**Re: Third Submission Review – 3411 S Fairplay Townhomes – Site Plan and Replat**  
Application Number: **DA-2302-00**  
Case Numbers: **2022-4028-00; 2022-3024-00**

## Third Submission Review

**3411 FAIRPLAY WAY SUBDIVISION FILING NO.1**  
 A RESUBDIVISION OF A PORTION OF LOT 2, SPINNAKER SUBDIVISION FILING NO. 2  
 SITUATED IN THE SOUTHEAST QUARTER OF SECTION 31, TOWNSHIP 4 SOUTH, RANGE 66 WEST  
 OF THE 6TH PRINCIPAL MERIDIAN, CITY OF AURORA, COUNTY OF ARAPAHOE, STATE OF COLORADO

# 3411 FAIRPLAY WAY - FILING NO.1

SHEET 1 OF 3

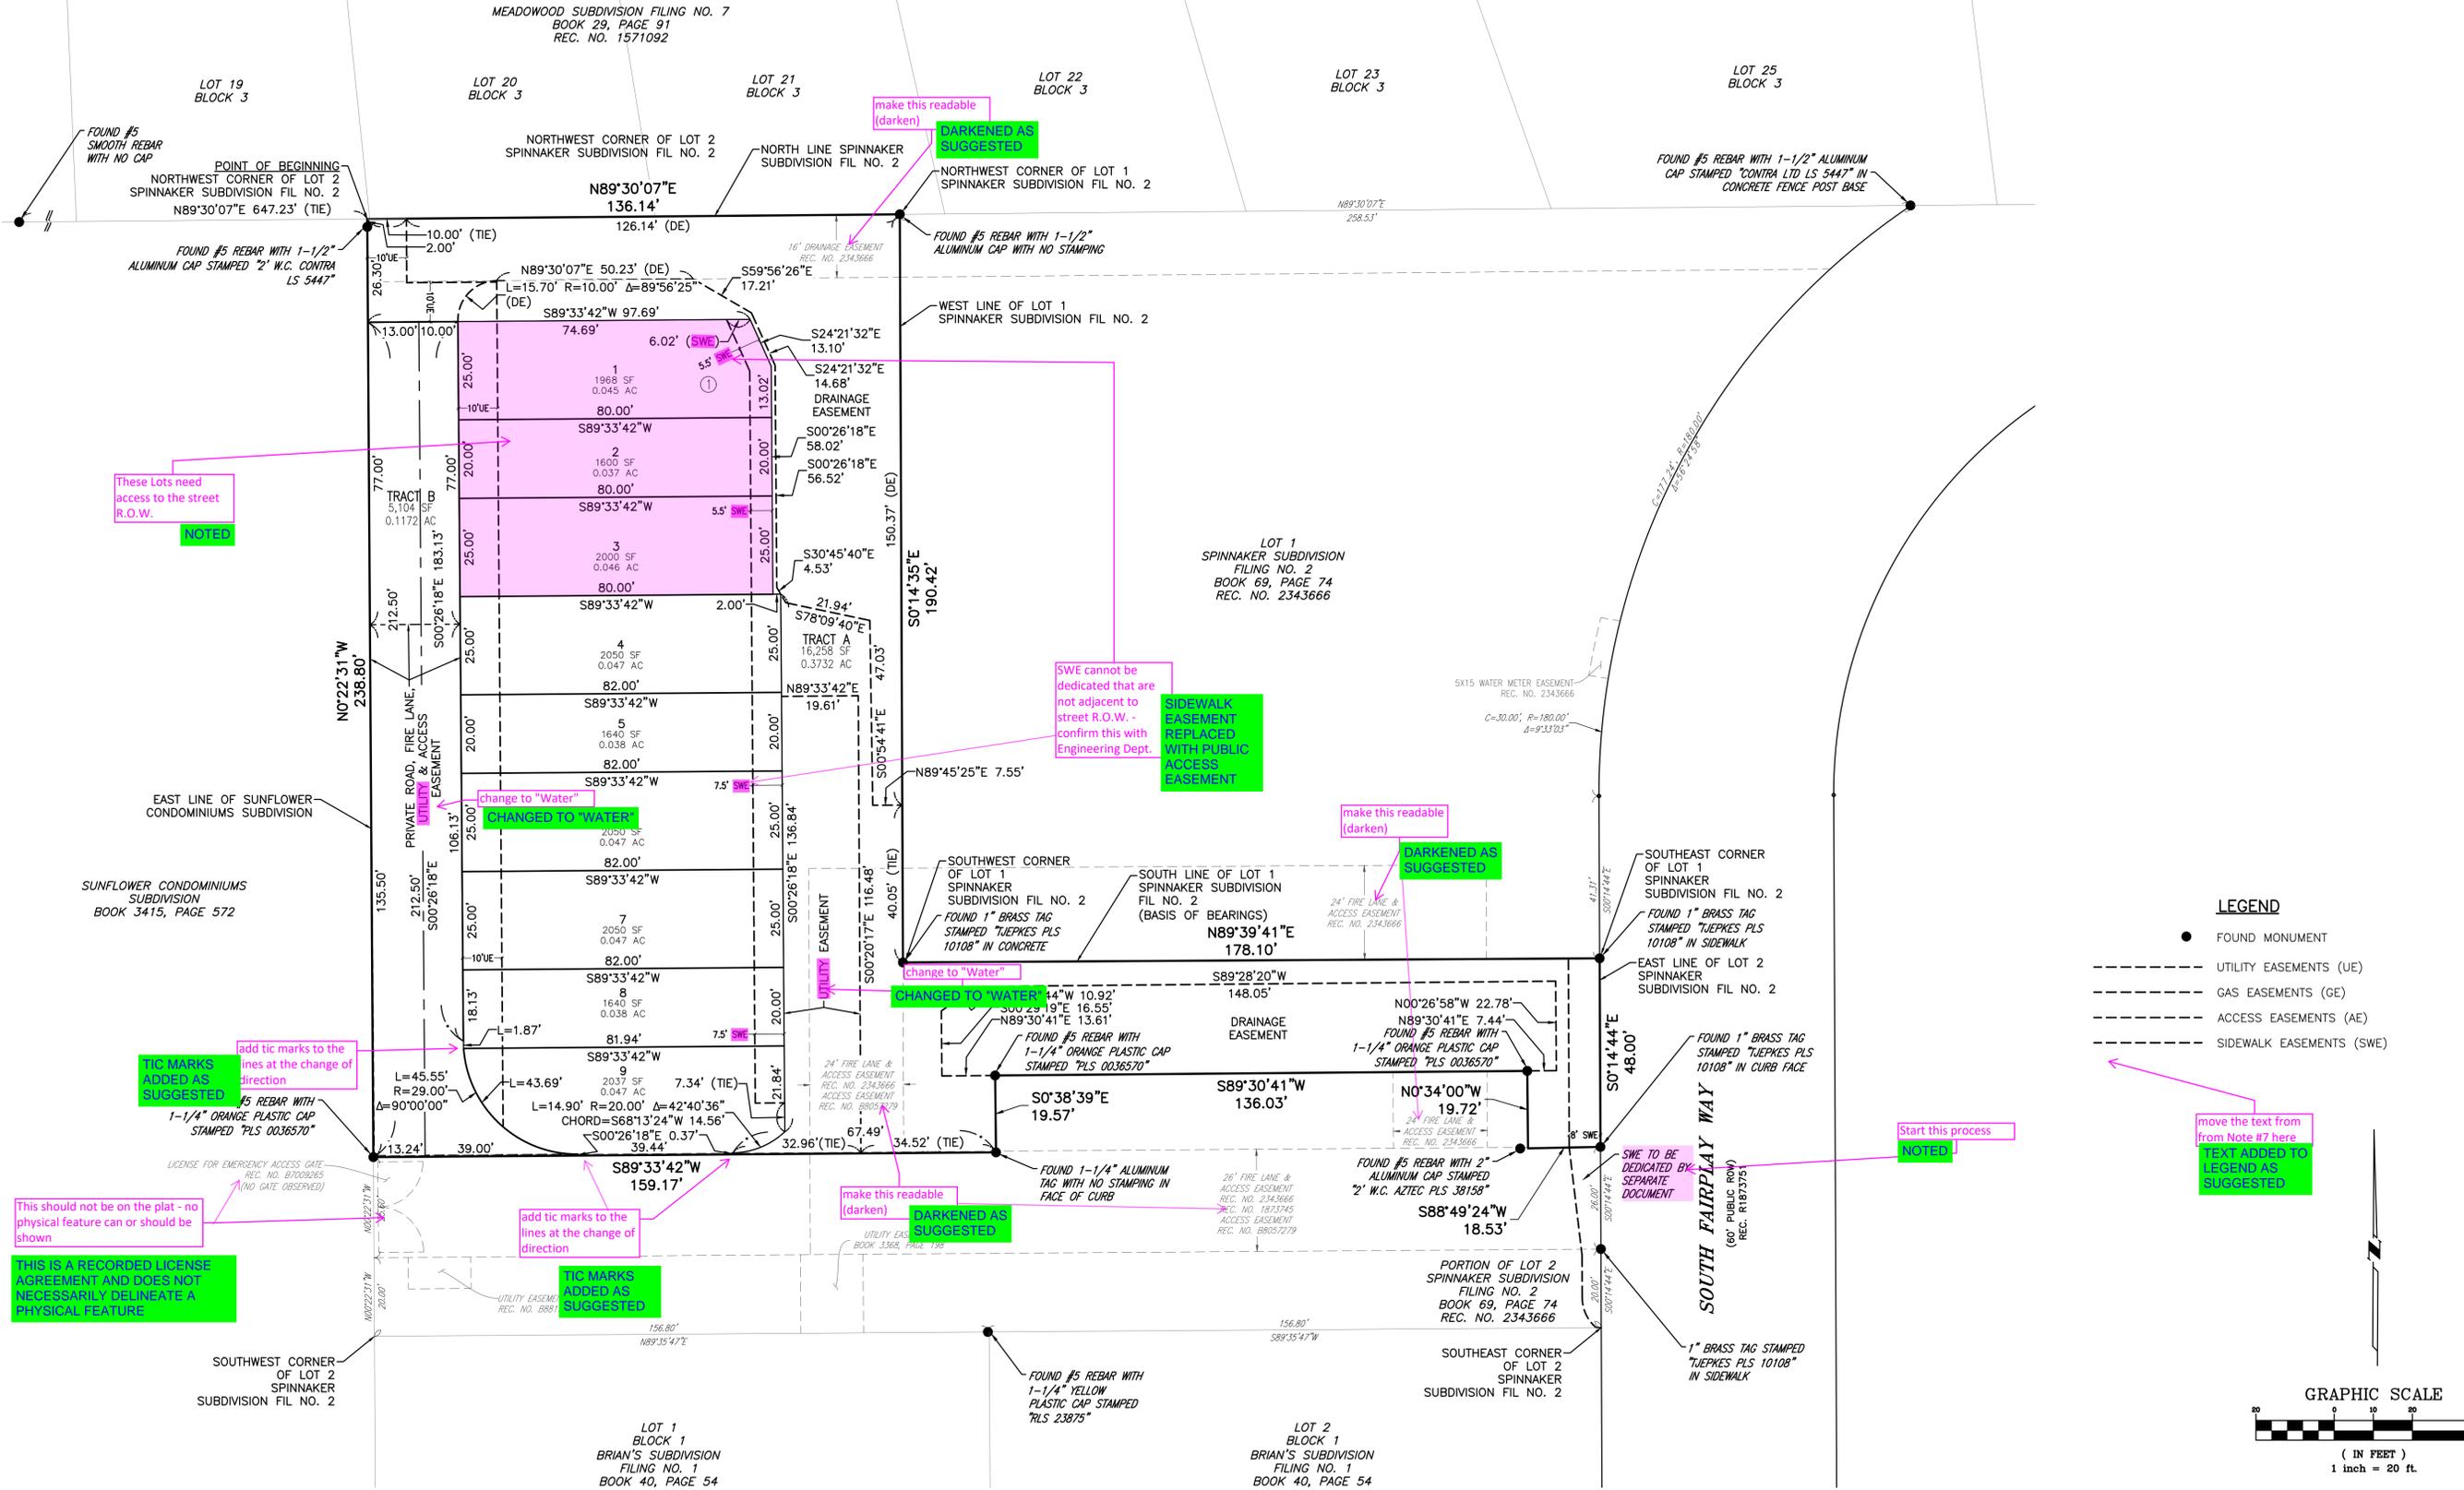
The County has changed this again to be 3" x 7" space without Text or graphic in that area. **REMOVED AND REPLACED WITH 3"x7" BOX**

Change this to line drawings - Color drawings do not scan well

This is not being dedicate hereon. (Delete)

add State of Registry, Match the Title Commitment

Final sheet will be deleted. Please modify with next submission.

**COLOR REMOVED FROM VICINITY MAP**

**STATEMENT DELETED**

**STATE OF LLC REGISTRY ADDED**

**LOGO DELETED**

PROJ NO: FAIRPLAY  
 ENG: \_\_\_\_\_  
 DATE: 04/21/2023  
 SHEET NUMBER  
 1 OF 9

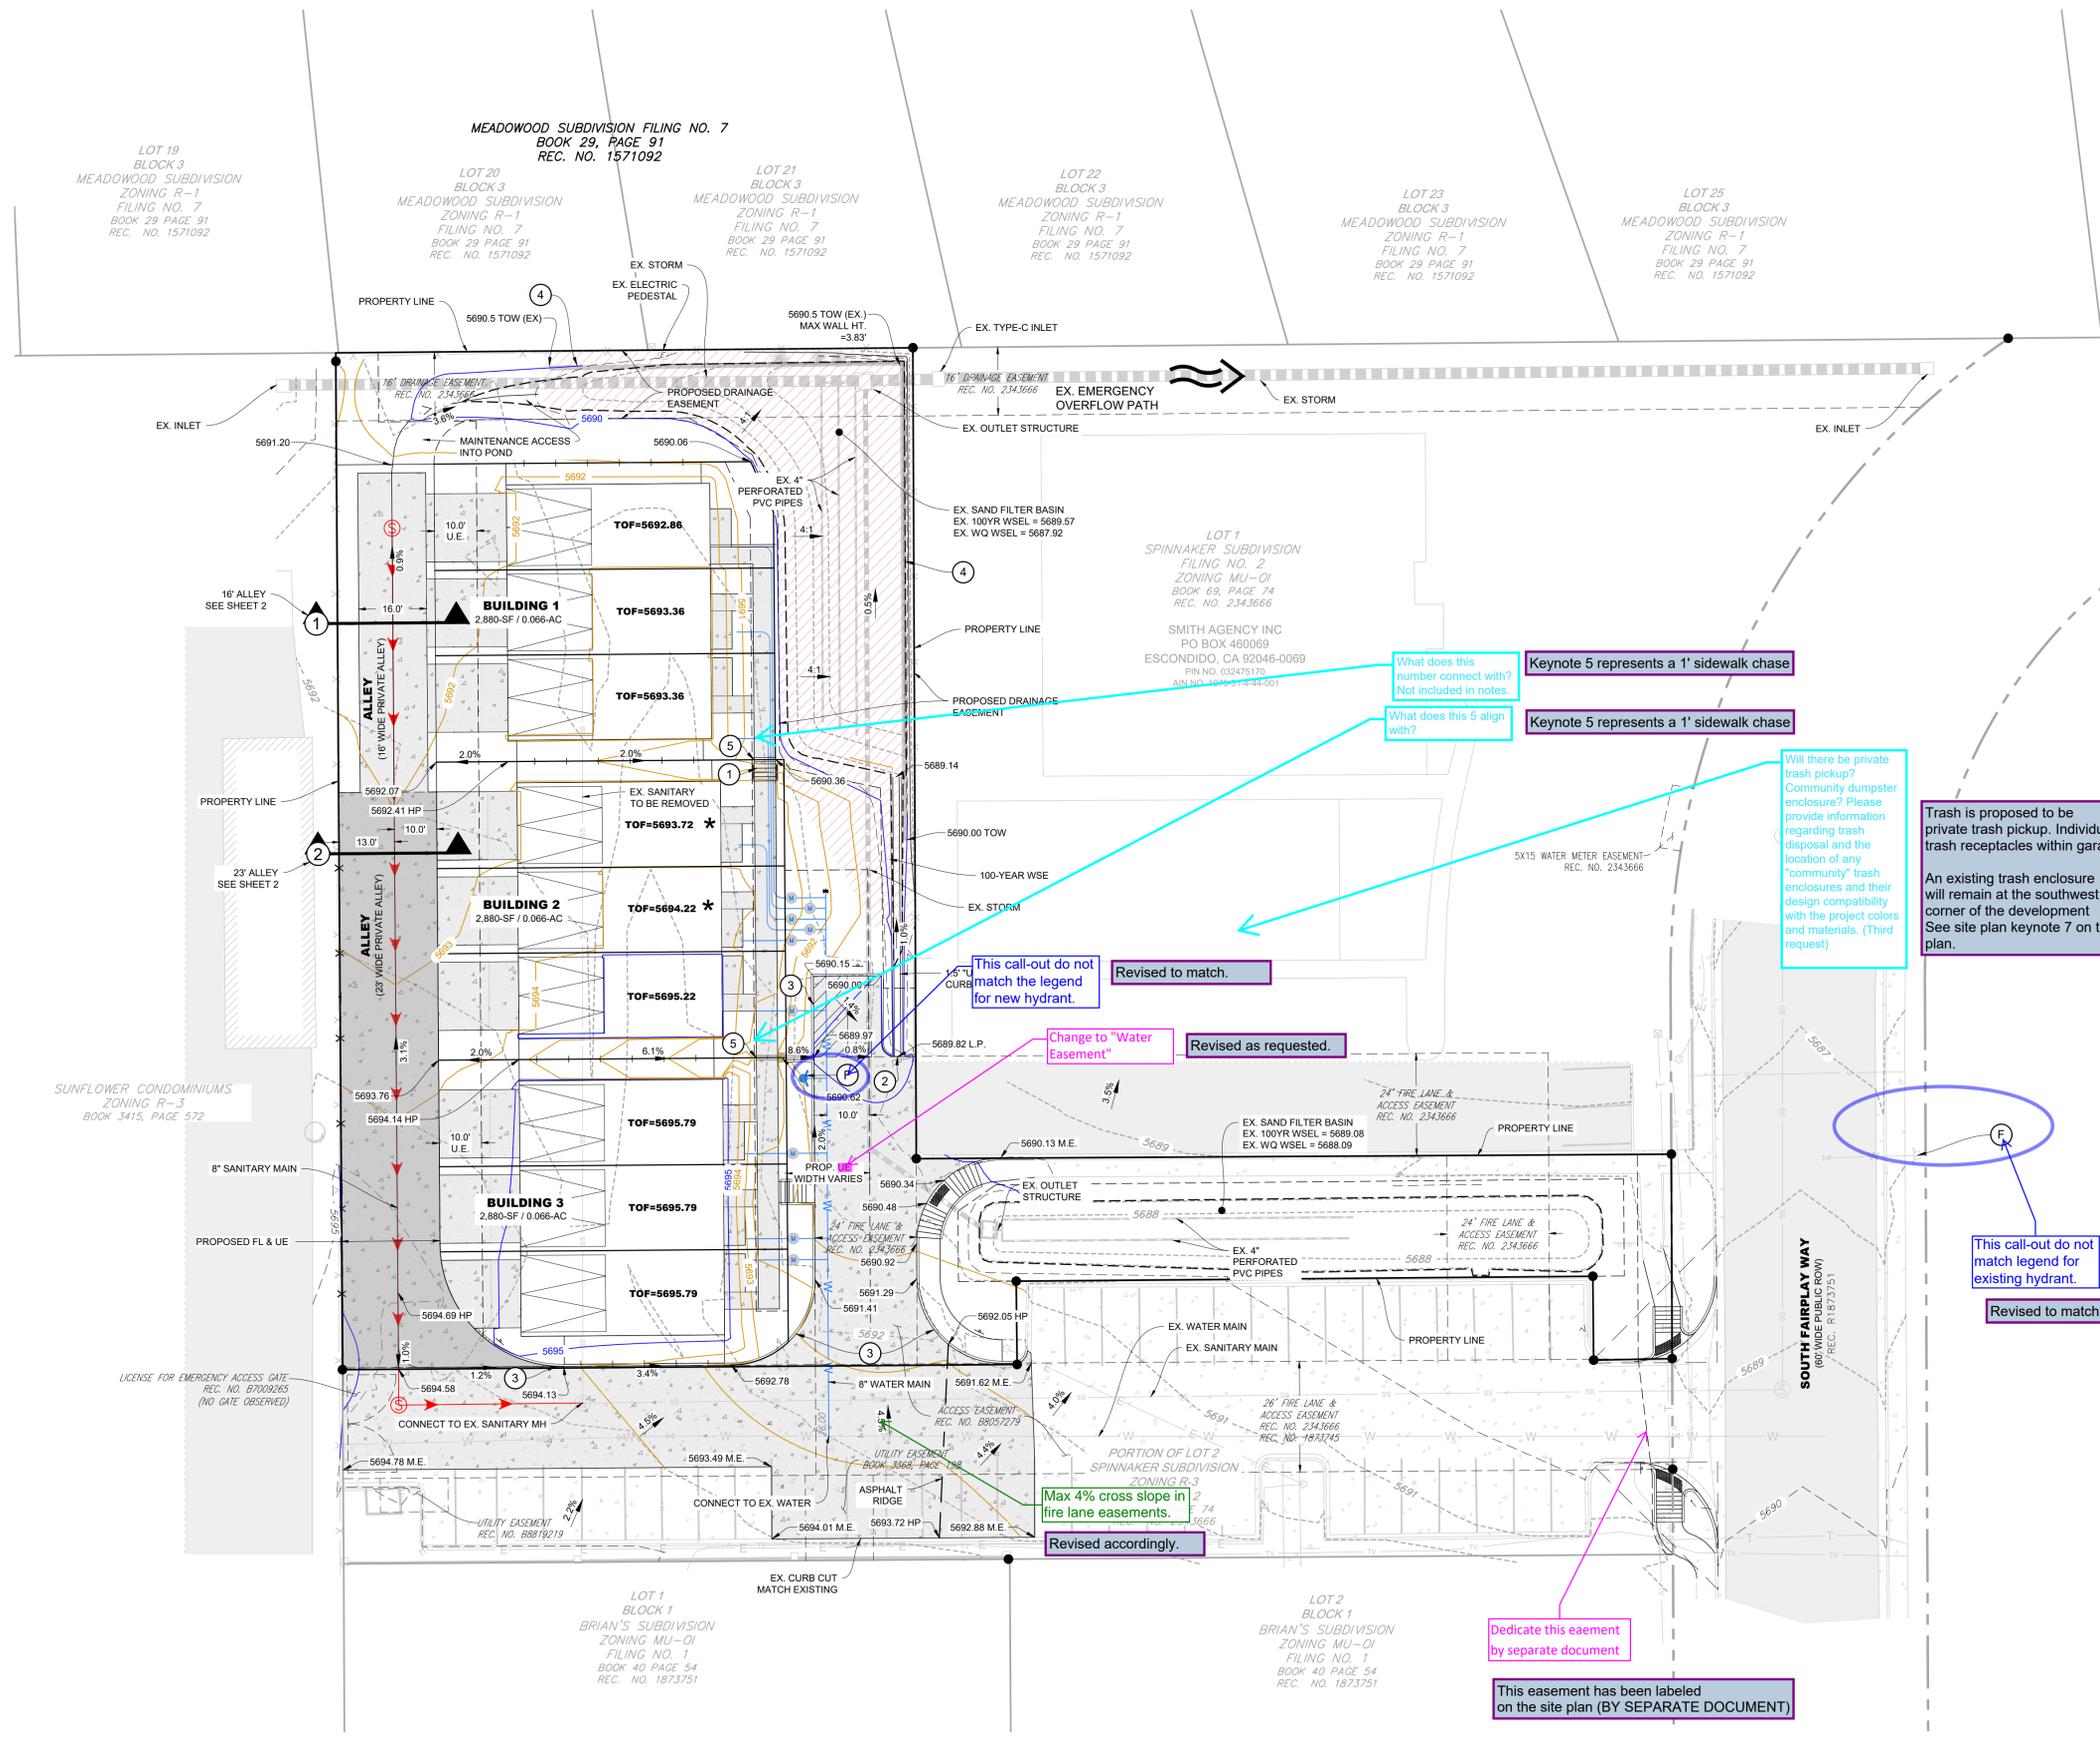
The adjustment request on the landscape plan indicates that a "6' tall wood fence" is being provided and not a masonry wall. Please clarify

Feel free to contact me with question about the implementation plan. Please complete table.

Please provide side, front and rear setbacks. Label accordingly and add to site data table. Third request.

Please explain in the LOI how the Shared Parking Agreement allows residents to utilize the adjacent parking lot. Provide information on which paragraph in the agreement allows for the use by residents and how it provides 7 additional spaces

Increase the font size of the sheet numbers.

Revised to be wood fence.

Implementation Plan Table has been added.

Setbacks have been added to the table and shown on site plan.

PROJ NO: MHL1.20  
ENG:  
DATE: 04/21/2023  
SHEET NUMBER  
7 OF 9

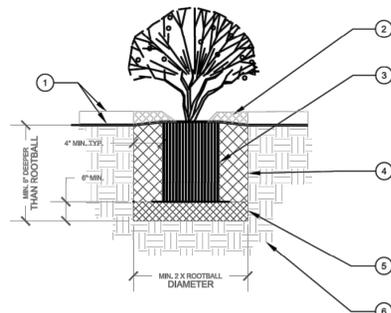
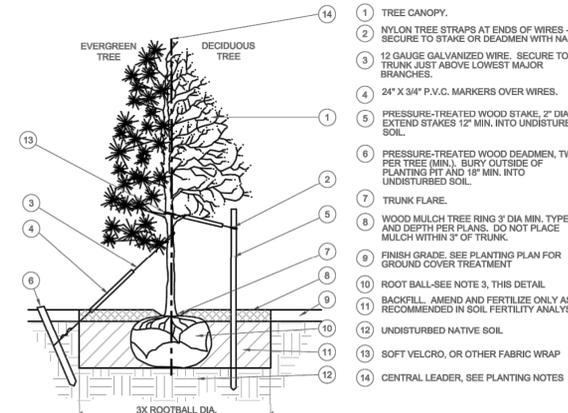
Include a detail of the proposed 6' tall fence.  
Include material and color.

Move to a different sheet. You may need an additional sheet to capture all of the needed elevations.

Response: Revised.  
fence will be unstained wood (ceder).

Response: This has been moved

SHEET 3 OF 3

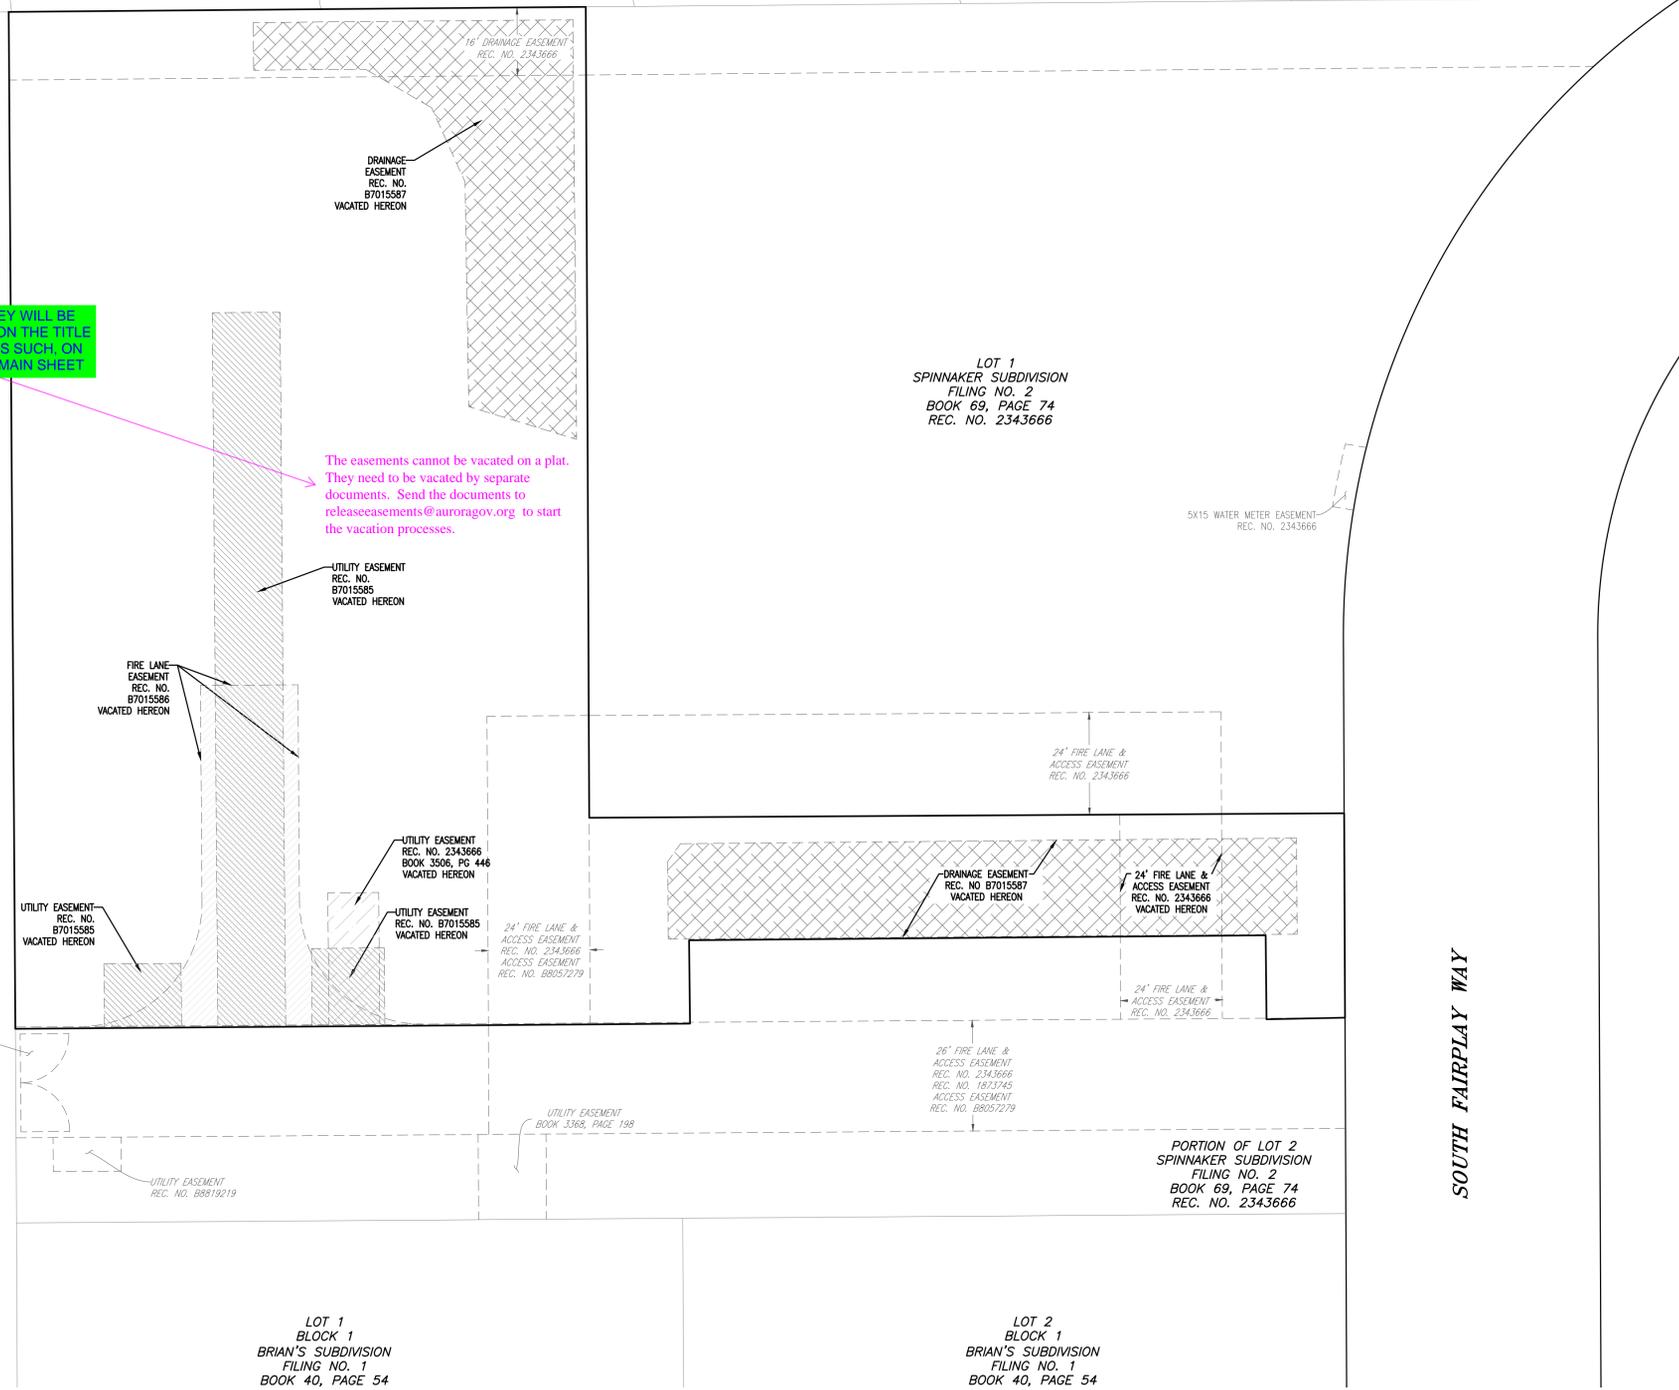
This page is not needed

The easements cannot be vacated on a plat. They need to be vacated by separate documents. Send the documents to [releaseasements@auroragov.org](mailto:releaseasements@auroragov.org) to start the vacation processes.

CONSIDERING THE EASEMENTS ON SHEET 3, WHILE THEY WILL BE VACATED BY SEPARATE DOCUMENTS, STILL SHOW UP ON THE TITLE COMMITMENT, WE CAN MORE CLEARLY SHOW THEM AS SUCH ON A SEPARATE SHEET RATHER THAN MIXED IN WITH THE MAIN SHEET
